JOINT REGIONAL PLANNING PANEL (Sydney East Region)

| JRPP No: | 2015SYE133 |
| DA No: | DA15/1134 |
| Proposed Development: | Mixed use retail, commercial and residential development and associated public park including 749 dwellings, fitout and use of 2 supermarkets, 1 liquor store, 9000m2 public park with lake and surrounding forest, 1500m2 community facility, Torrens subdivision for road dedication, Torrens subdivision of 1 lot into 2 lots for public reserve dedication, 5 lot stratum subdivision and signage strategy |

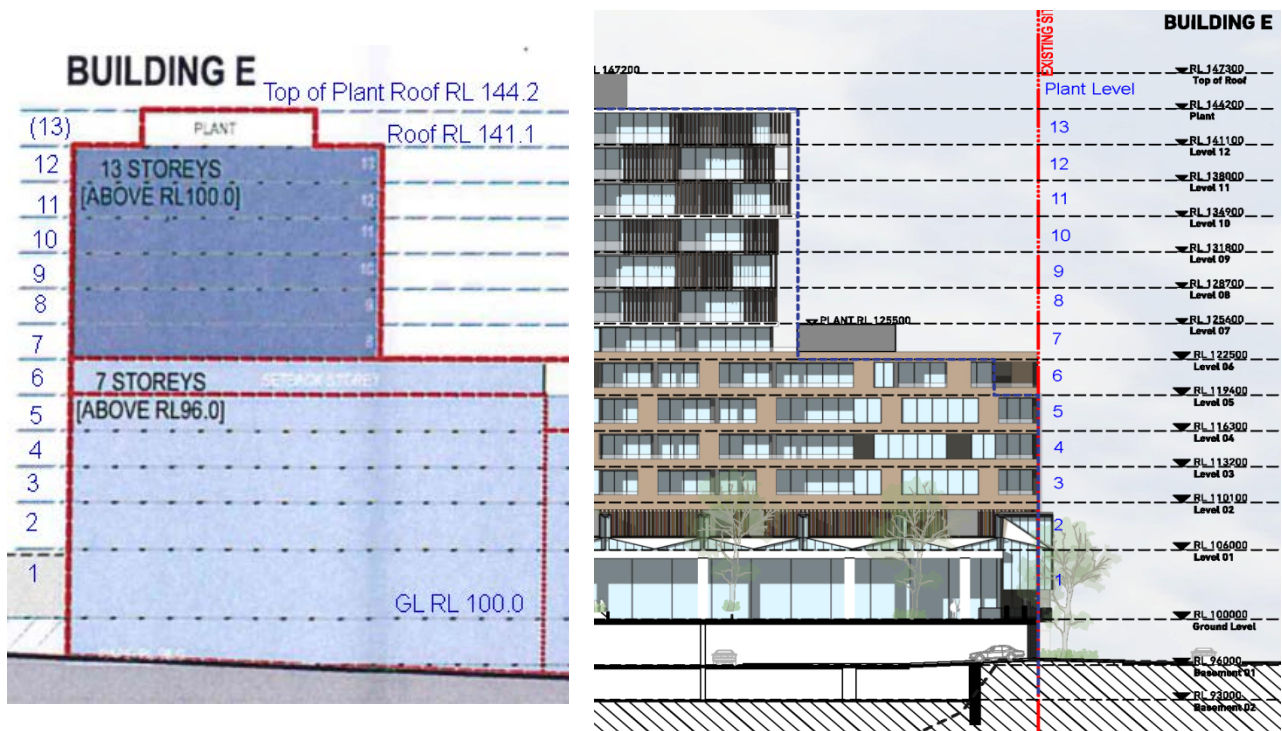
Building E is more than 3m above the ‘maximum’ heights presenting visually as an additional storey from that depicted in the Concept Elevation Diagrams. Unlike other building envelopes, an anomaly exists in the notation for Building E in the Concept Elevation Diagrams. Based on the finished RL’s, the Plan should depict the building as 12 storeys of residential above RL100 (refer to below Concept and proposed plans). The applicant has applied the 13 storeys for residential use ‘literally’ and provides for an additional level (with a plant room above that level) rendering Building E over 3m higher than the RL’s specified within the Concept Elevation Diagrams.

Council recommends that all vertical apartment towers which exceed the maximum roof and plant levels specified in the Concept Approval be reduced in height to comply. This can be achieved with the removal of the upper floor level(s) of each vertical apartment tower and / or minor adjustment to the internal ceiling heights where possible. Any reduction in internal heights should not however reduce internal residential amenity and compliance with relevant building standards and the Apartment Design Guide (e.g. plan / room depths and solar access). Should Building A be reduced by a storey, it is recommended that the 11 storey eastern component of Building A be also reduced to 10 storeys so as to enable an appropriate scale transition of built form along the Princes Highway.

Should the Joint Regional Planning Panel be satisfied that the minor variations in building height (300mm – 1.4m) from the Concept Approval can be supported without modification to the Concept Approval through the Section 75W process, Council will remain of the view that Building E is substantially not in accordance with the Concept Approval and should be reduced by a full storey (i.e. Residential Level 12).

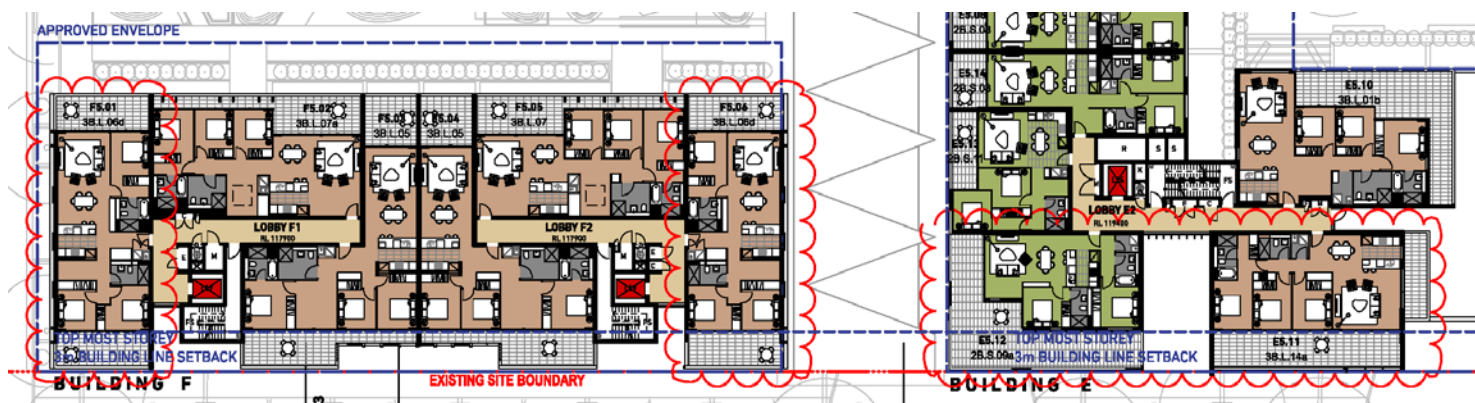
Building D provides the least amenity in terms of 'way finding' and common circulation for residents which is discussed further in this report. A suitable location for a reduction in residential GFA is with the removal of apartments D10.08 – 3 bedroom (118m²) and D6.07 – 2 bedroom (75m²). These apartments are located on upper floor / edge locations of Building D and would lessen the quantity of residential apartments lacking higher amenity. The resultant built form would both lessen the visual width / mass of the building and increase building separation.

Council recommends that a suitable condition be imposed to enable a degree of flexibility in the design incorporating either the above design opportunities and providing an alternative

whereby the applicant can undertake the GFA reduction elsewhere in the development to the satisfaction of Council. This will enable the full permitted 68,310m² of GFA as approved in the Concept Plan to be realised.

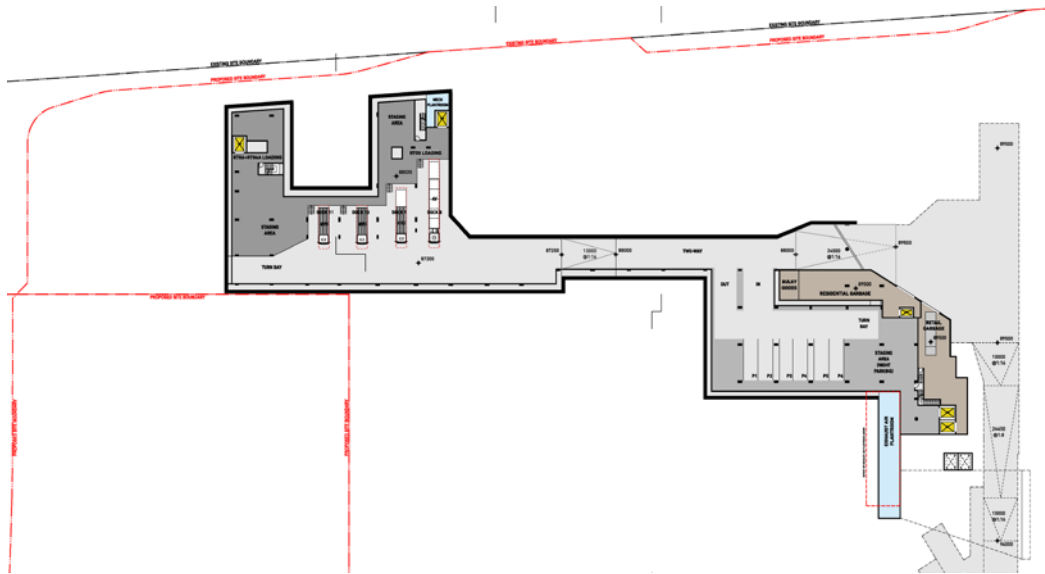
Condition B2A (Building Envelopes 'E' and 'F') of the Concept Approval requires the buildings to provide a minimum 3m setback to the 7th storey fronting Flora Street in order to achieve an appropriate scale of development. The submitted plans depict a 3m setback to the external glass line of the 7th storey of Buildings E and F, however there are projecting active use balcony spaces (and balustrades), blade walls, and stair wells (vertical circulation cores) located within the required setback (out to the street boundary).

Whilst in principle Council acknowledges that the secondary balcony spaces will enhance residential amenity and add architectural interest to the building, it is Council's view that the specific design parameter has not been satisfied, and as with building height / GFA, support for the variation cannot be provided unless modification to the Concept Approval is made.

The blade walls and trafficable balconies encroaching within the 7th Level 3m setback of Building E are also recommended to be deleted and door openings to the balconies be converted to windows. The eastern orientated balcony of Unit E5.11 is however required to be enlarged to the minimum required to satisfy the ADG and Council's DCP. To further reinforce the intent of the Concept Approval, the roof form projecting over the 7th storey balconies is also recommended to be reduced to the length of a standard projecting eave in order to achieve an appropriate scale of development.

Council recommends that Building F be relocated approximately 900mm northward within the site (i.e. to the minimum distance of the stair well encroachment within the 3m setback) or a combination of both relocation / adjustment to the internal floor plan to achieve the full 3m setback. Blade walls and balconies encroaching within the 7th Level 3m setback must also be deleted. The reduced balcony areas can be converted to narrow Juliet style balconies (i.e. balustrade edge moved to 3m setback alignment) or alternatively be deleted from the development and reinstated with window openings. It is noted that reasonable amenity is still achieved as these southern orientated balconies are secondary spaces accessed from passive use bedroom areas. Opportunity also exists for the internal non bedroom areas of Units F5.03 and F5.04 to be utilised for additional balcony space.

Original Proposed Entry From Flora Street

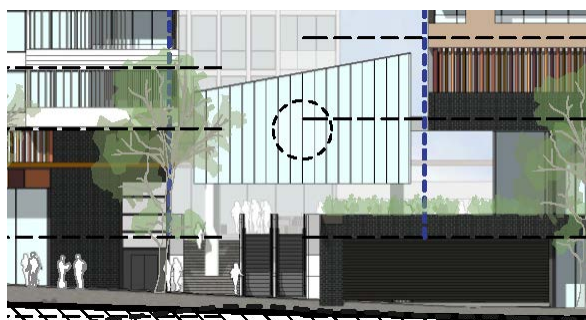
The revised pedestrian access from Flora Street to the Pedestrian Mall entry (between Buildings E & F) alienates the development from the public area and creates CPTED issues. The original configuration is a more appropriate outcome.

The legibility and ease (levels etc) of access, including public access to park from Flora Street has been an area of general concern. The applicant has amended the proposal whereby the eastern most pedestrian access from Flora Street has been modified to a single stair set / elevator to not detract from the primary entry point adjoining the public park. The design modification whilst enabling dual vehicular entry to the basement level, does not result in appropriate streetscape presentation and 'way finding' from Flora Street to the pedestrian mall level. In order to increase activity, general surveillance and legibility of access from Flora Street, Council recommends that the originally submitted design scheme be reinstated for this portion of the development.
